March 1, 1984

SUBJECT: REPORT ON THE REVIEW OF THE DIESEL GENERATOR  
BUILDING AT MIDLAND

REPORT ON THE REVIEW OF THE  
DIESEL GENERATOR BUILDING AT MIDLAND

FIGURE 1

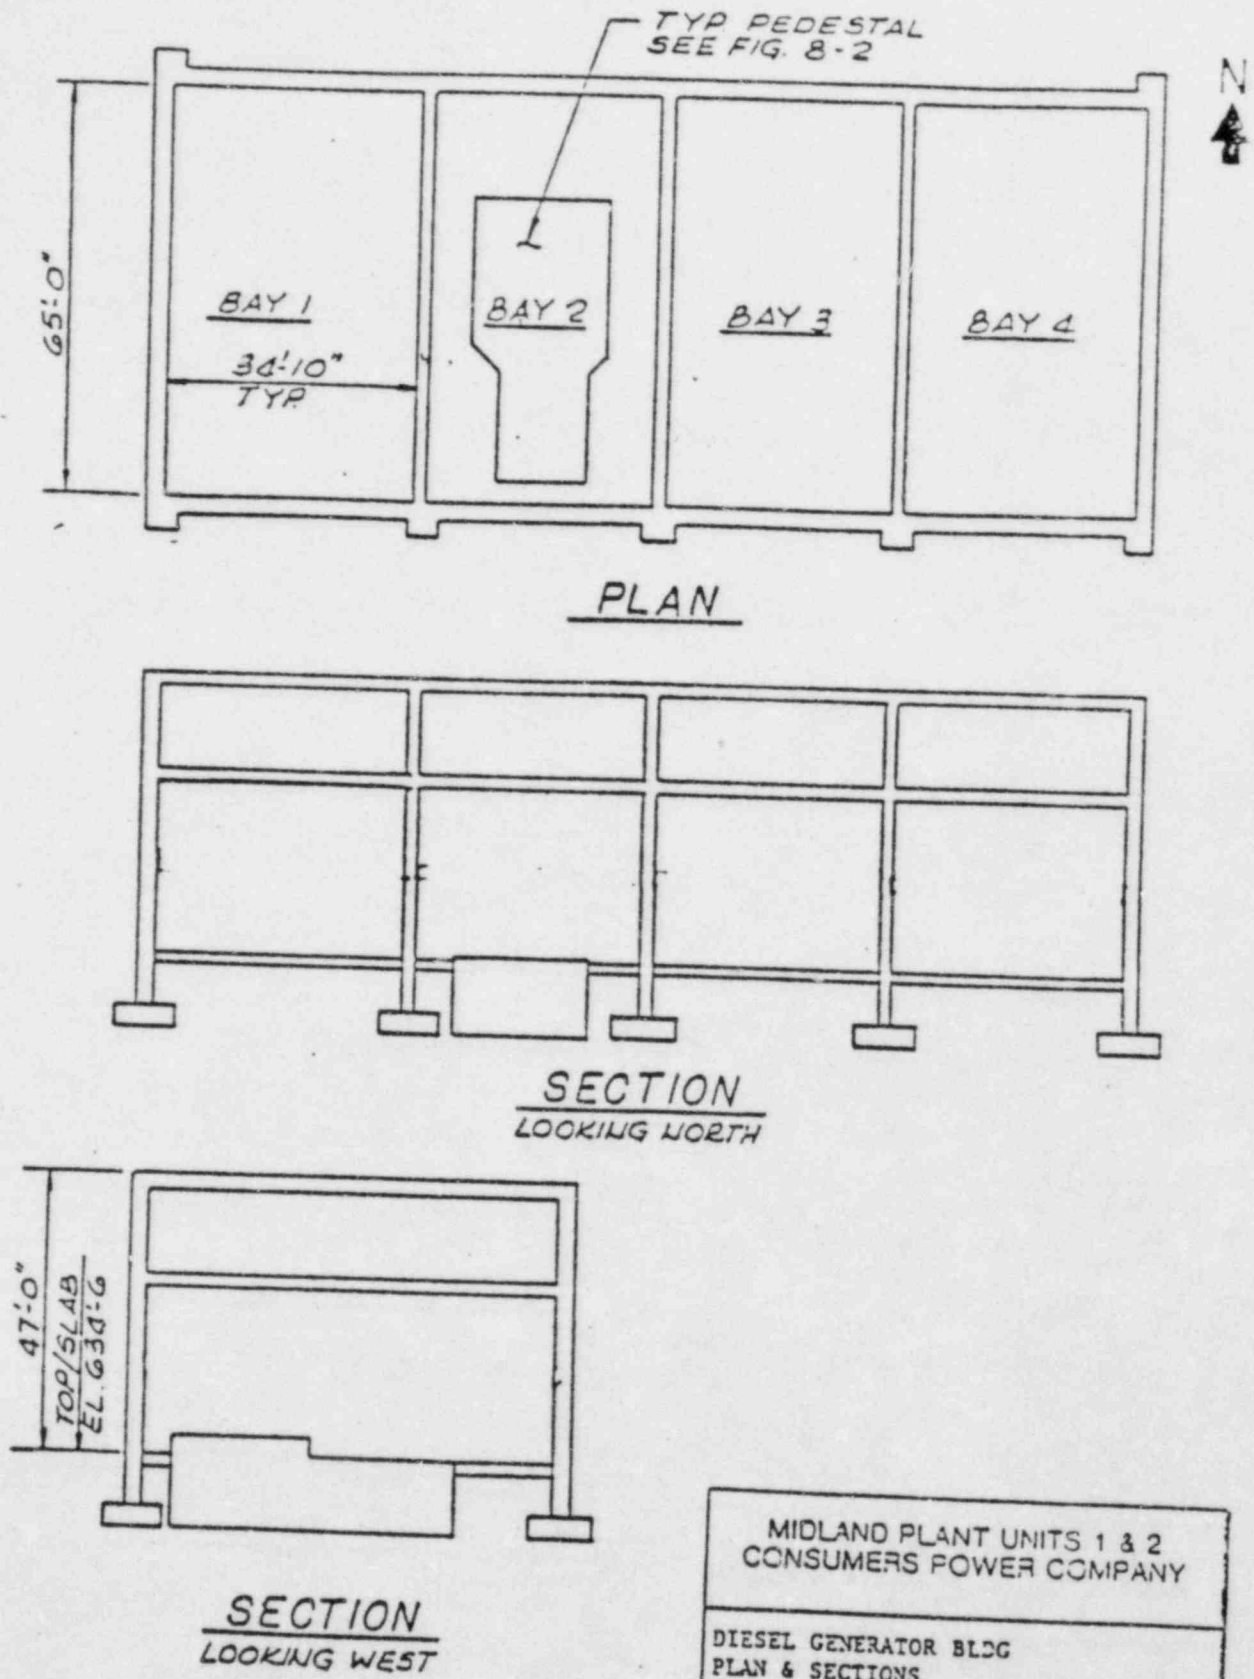
The DGB is a two-story, box-type reinforced-concrete (RC) structure with three cross walls that divide the structure into four cells, each of which contains a diesel generator unit. The building is supported on continuous RC footings 10' - 0" wide and 2' - 6" thick founded at plant elevation 628' and resting on a fill that extends down to approximately elevation 603'. The building has exterior wall thickness of 30", roof slab and interior wall thickness of 18". Plan dimensions of DGB are 155' x 70' with a total internal height of approximately 44'. Each diesel generator rests on a 6'-6" thick, RC pedestal that is not structurally connected to the building foundation. Figure 1 shows the general layout of the DGB.

FIGURE 2

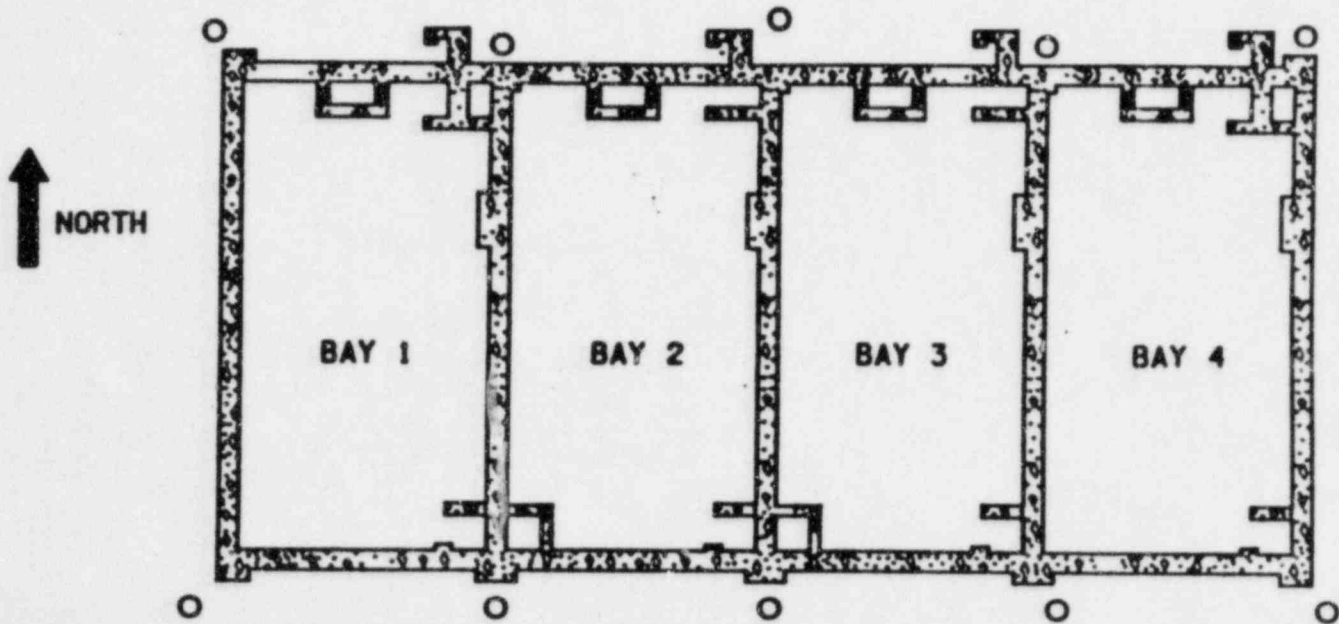
3. Inconsistences in the documentation of the settlement history needs to be resolved. For example, the Midland Units 1 and 2 Executive Summary dated August, 1983 states that for the July 1978 period, the maximum settlements recorded were 3.5 inches while Figure ES-14 of the same document indicates a maximum of 1.99 inches for the same period.

Peak settlements anticipated at the end of 2025 (actual settlements to date plus secondary settlements from now till then) are specified in Ref. 7 to vary from 4.79 inches (under the NW corner) to 9.33 inches (under the SE corner). However, it should be mentioned that the exact settlement history at the various settlement markers at the DGB is open to question. For example, it is mentioned in Ref. 7 that the maximum settlements in August 1978 were about 3.5 inches. Yet the data used in the stress analyses for the presurcharge period (Figures ES-14 of Ref. 7) indicates peak settlements of only 1.99 inches. It was stated at one of the Bechtel presentations that prior to cutting the duct banks loose from the footing, footings along the North wall actually lifted off from the soil, with the DGB rotating about the duct banks. There is no indication of this behavior in any of the settlement data used in the computations. Ref. 8 lists the settlement increment from 8/79 to 12/2025 to be 2.36 inches under the SE corner of the building. For the same period Ref. 7 lists this data as 1.89 inches. Thus some inconsistencies appear to exist in the various documents.
